November 24, 2025

OHIO RIVER TUNNEL

ADDENDUM No. 7

Former Crivelli Chevrolet Drawing Sheets

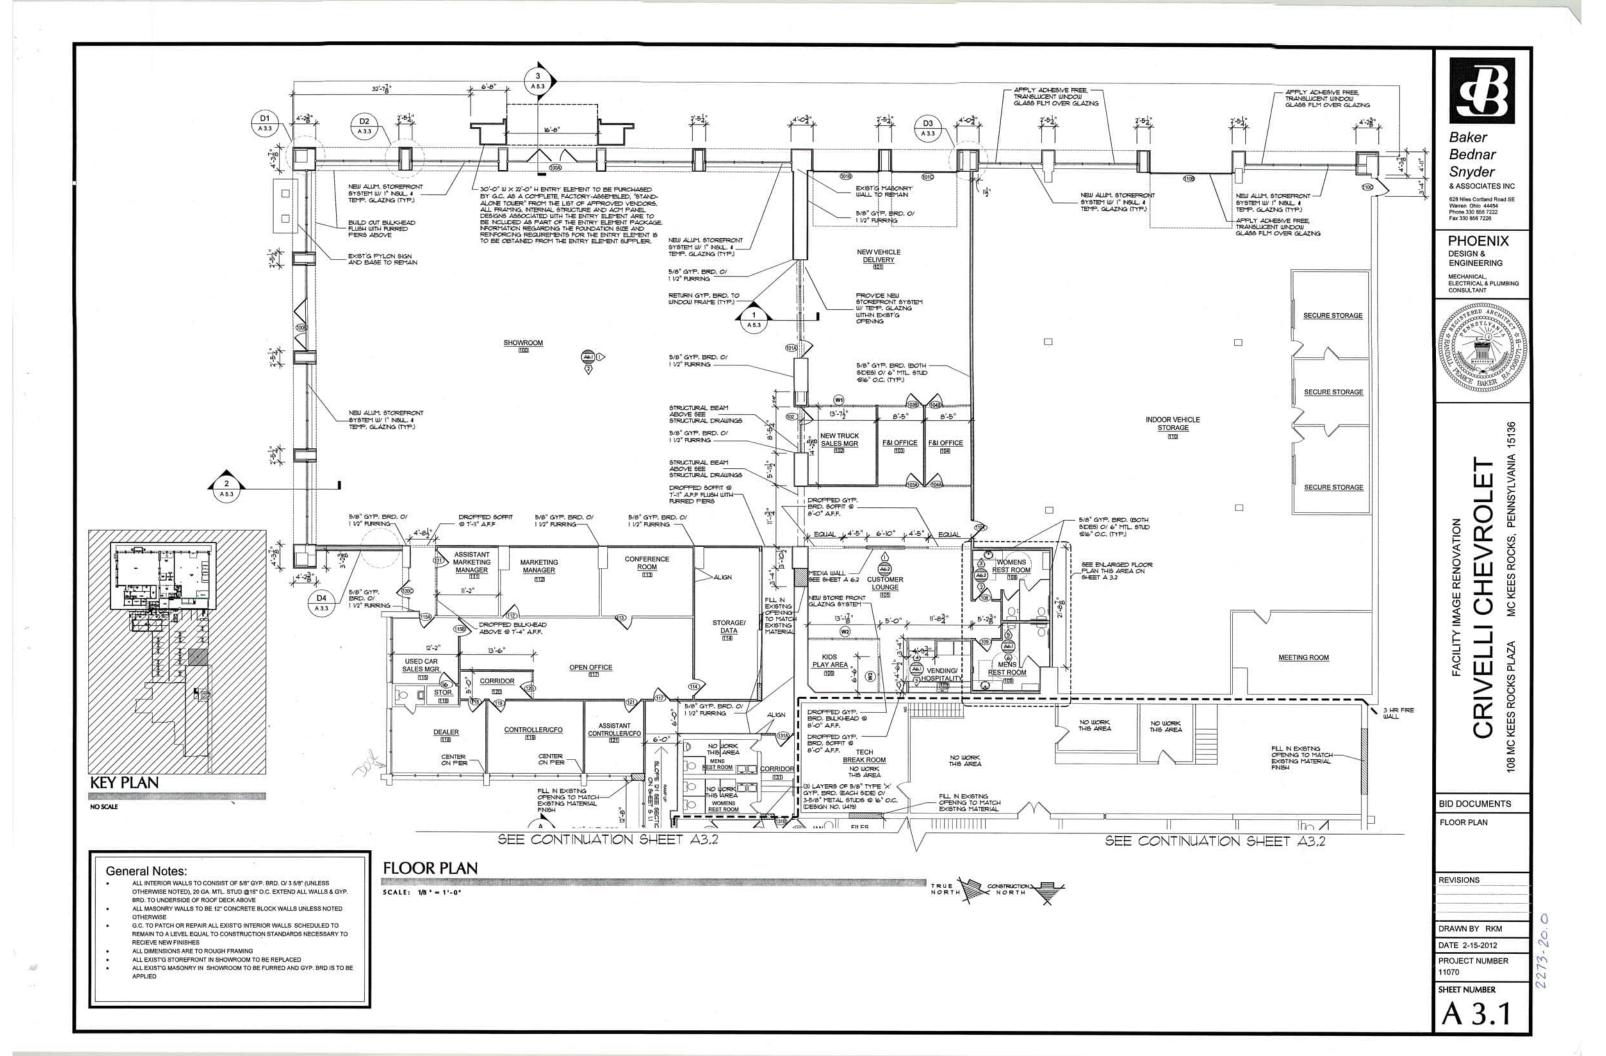
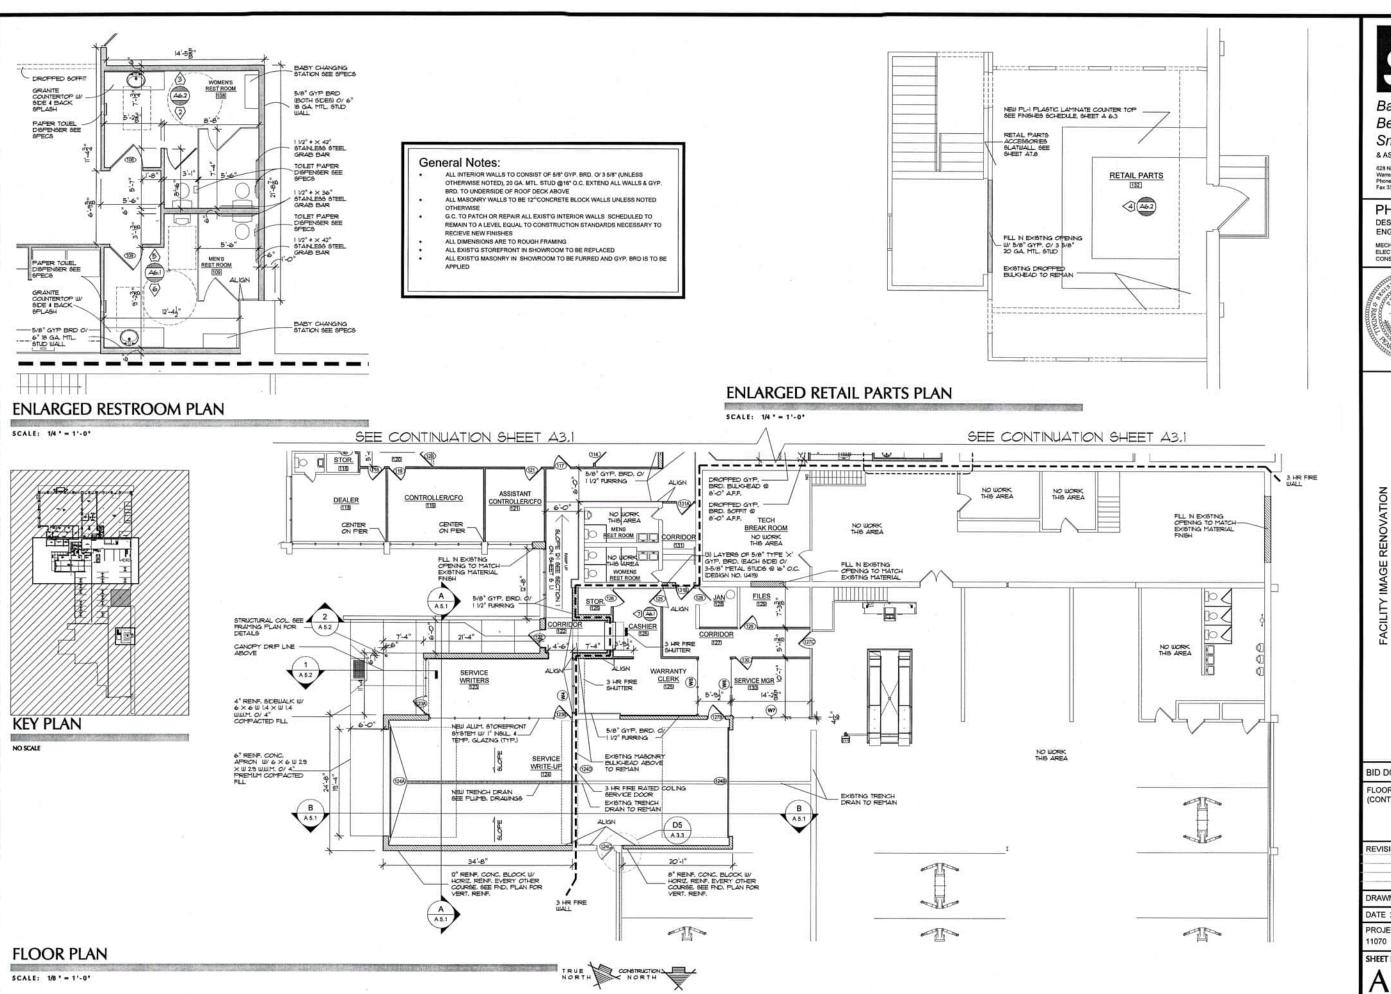
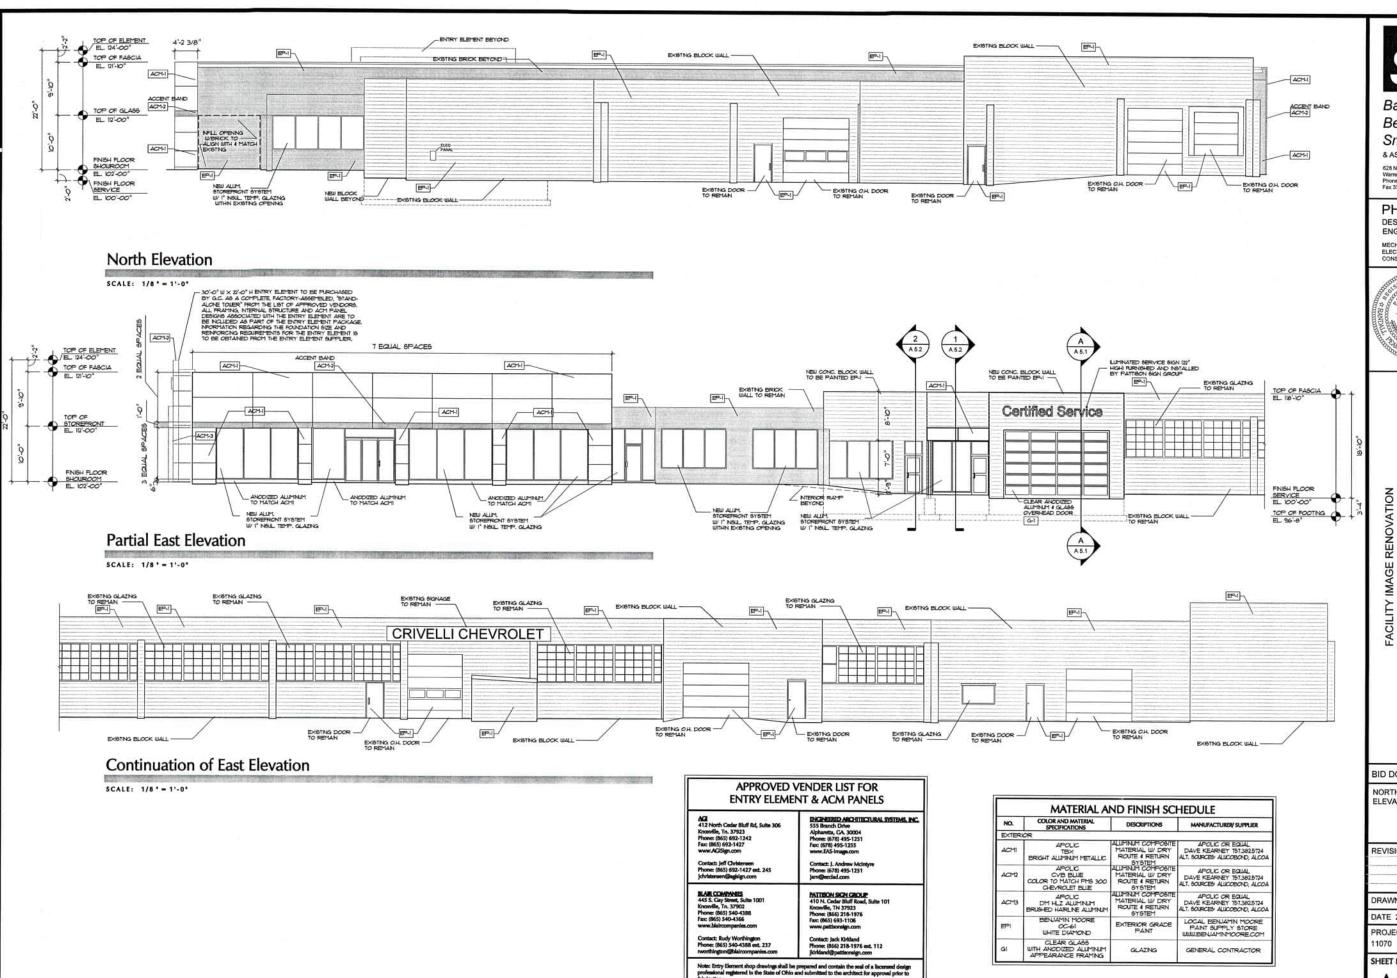
- Q1 Please provide drawings of the existing floor plan for the former auto dealership building at site CCT-007A that will be made available to the contractor for temporary offices and other purposes.
- A1 Drawings for the former Crivelli Chevrolet auto dealership have been added to Appendix E, Section 10. See Attachment I of this Addendum.

CCT-ST-012.dwg CCT-ST-012 NON-TBM TUNNEL - CONCRETE LINING 11/21/2025 Sheet: TUNNEL DETAILS SHEET 3 OF 3 093 OF 770

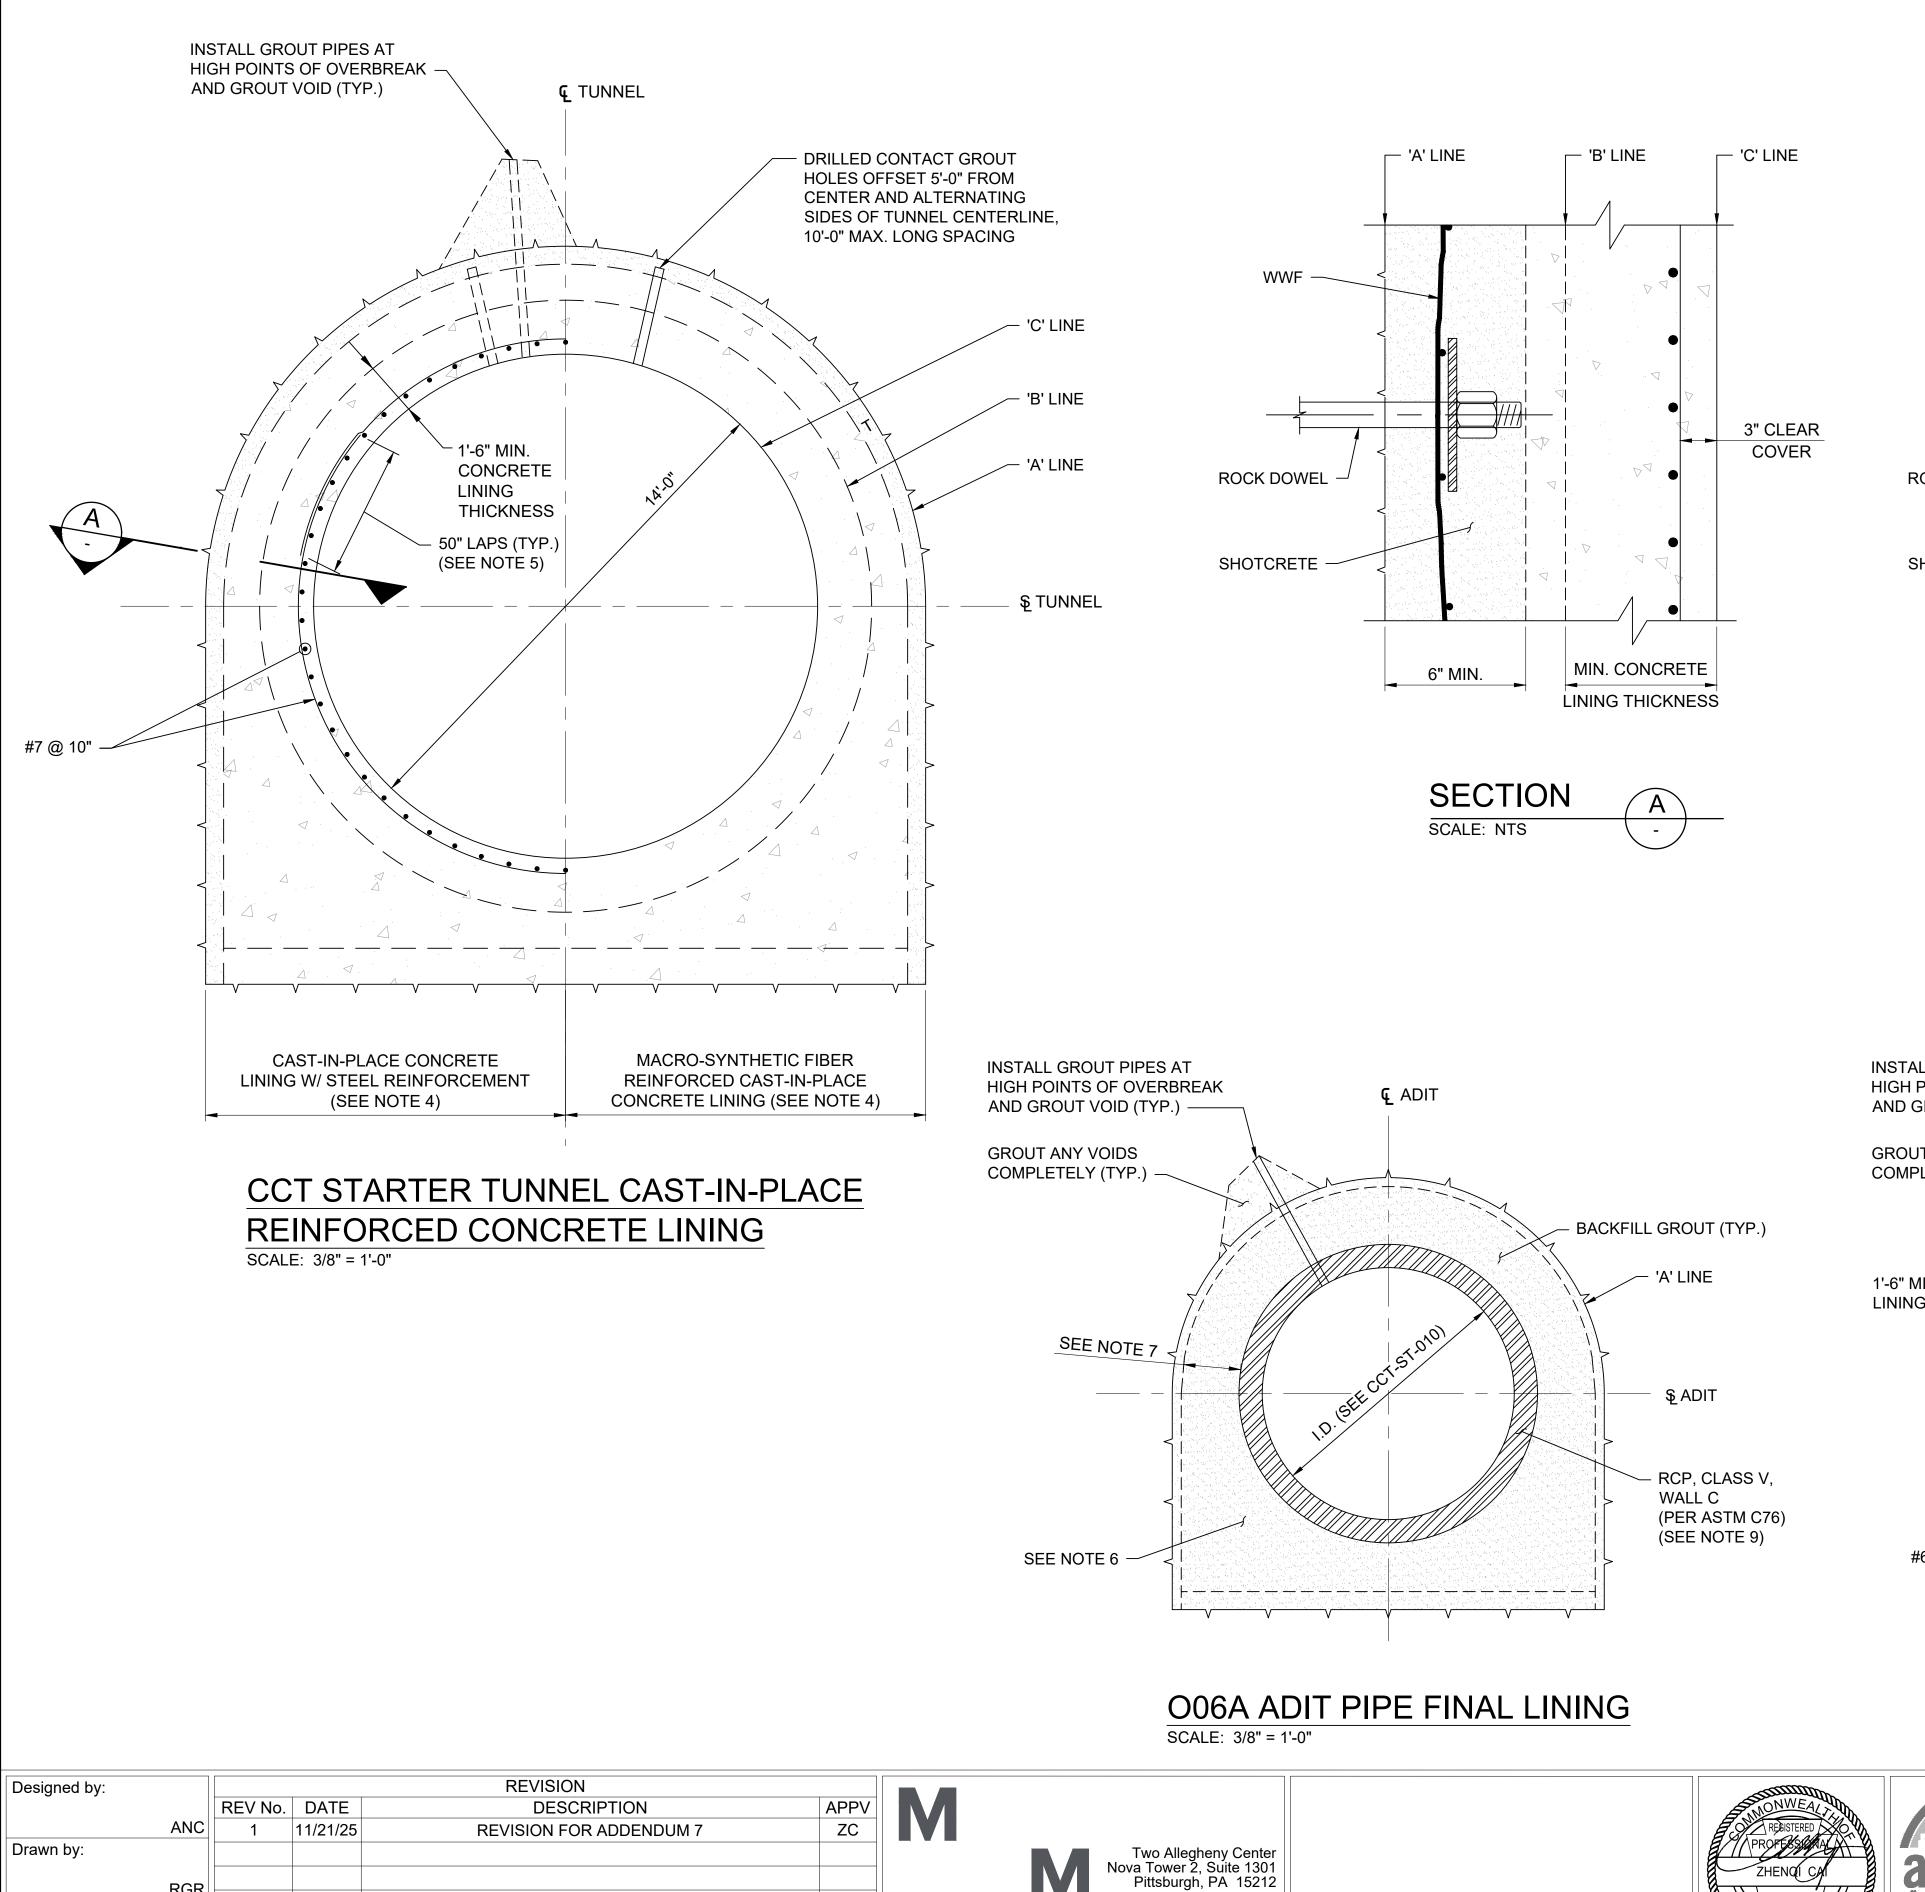
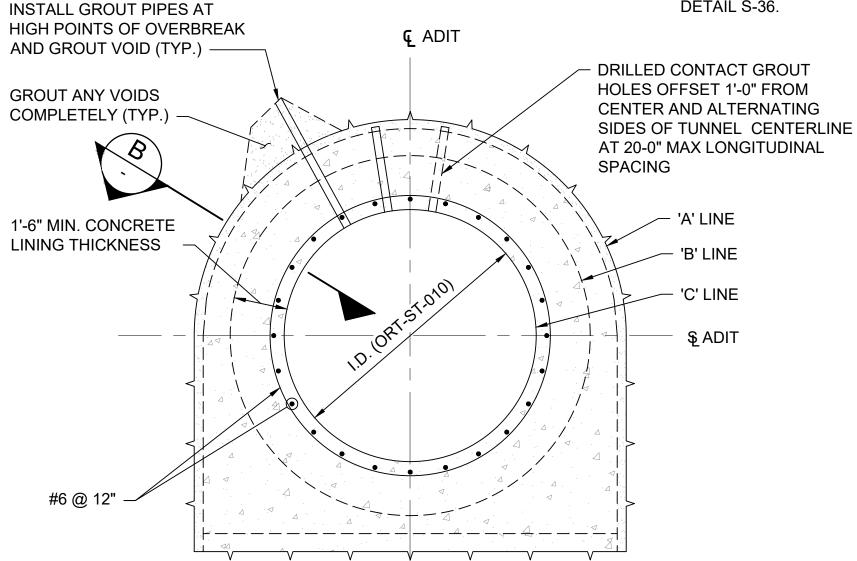
- Q29 Note 9 on sheet CCT-ST-012 states RCP is not allowed between STA 60+00 and STA 92+00 along the CCT-006A tunnel alignment whereas the CCT-006A adit is to be excavated from STA 0+00 to STA 19+00. Are there locations in the CCT-006A tunnel where RCP is not allowed?

- A29 RCP is not permitted only within the tight curve between STA 0+62.86 and STA 0+92.28 Refer to revised drawing sheet CCT-ST-012.

- RCP IS NOT ALLOWED BETWEEN STA 0+60.86 AND STA 0+90.28) ALONG THE CCT-006A-AD ALIGNMENT. CONTRACTOR SHALL INSTALL CAST-IN-PLACE REINFORCED CONCRETE LINING AS SHOWN HEREIN AND PROVIDE STRUCTURAL CONNECTION WITH THE RCP TO EACH SIDE BASED ON STANDARD PIPE TO CONCRETE WALL CONNECTION DETAILS AS SHOWN ON SHEET ORT-MD-007. DETAIL S-36.
